05.1-14

## TECHNICAL BULLETIN

### Engine Misfire/Starting Difficulty – Harness Connector Modification

MODEL 1995-96 MY  
Sedan (4.0L) Range  
VIN  
720001-771156

ILLUSTRATION 1

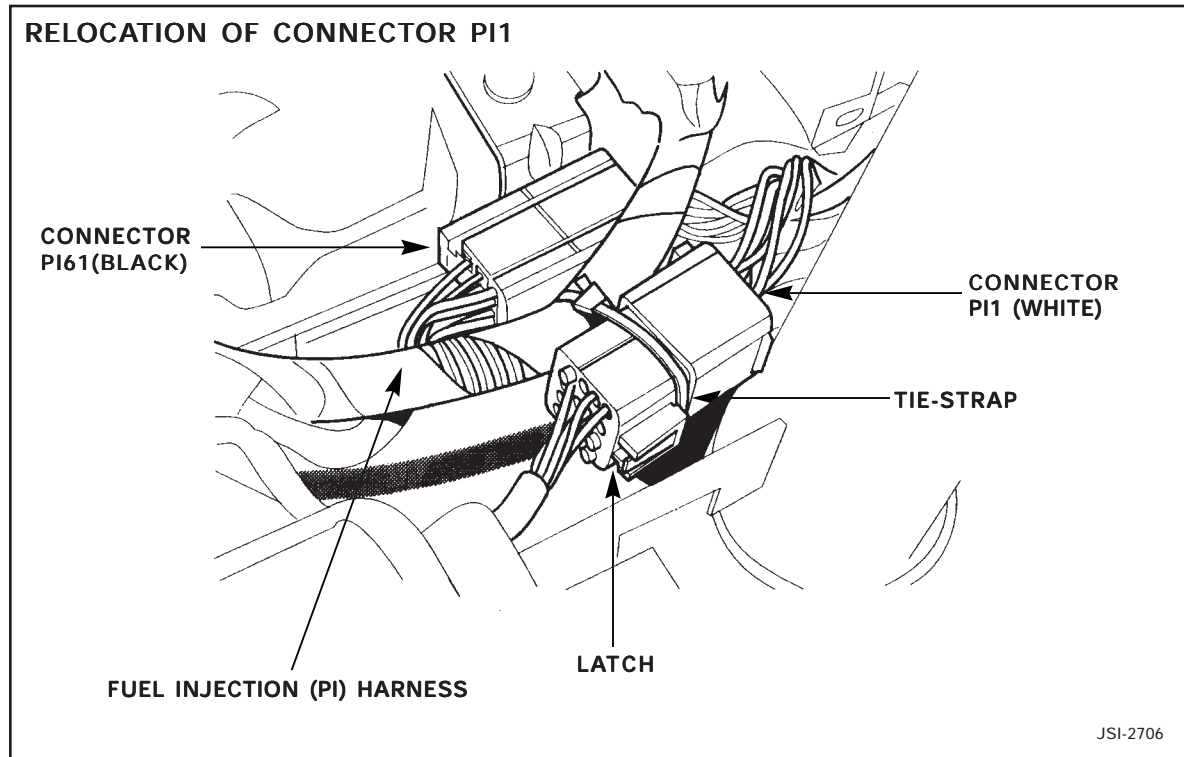
Some 1995-96 MY Sedan Range vehicles within the above VIN range may exhibit engine misfire/starting difficulty due to terminal corrosion caused by the entry of water at connector PI1. The condition has been found on 4.0L Sedan Range vehicles, however, connector PI1 carries the engine management power supply on all engine variants on 1995-96 MY Sedan Range vehicles.

The connector was modified beginning with VIN 771157. The modification can be made on earlier vehicles if corrosion is found.

## RELOCATING CONNECTOR PI1

1. Do not return connector PI1 to its original location in the bracket below the black connector PI61.
2. Secure the white connector PI1 (Illustration 1) to the fuel injection (PI) harness using a tie-strap so it is adjacent to the black connector PI61. Position the latch outwards as shown in Illustration 1.
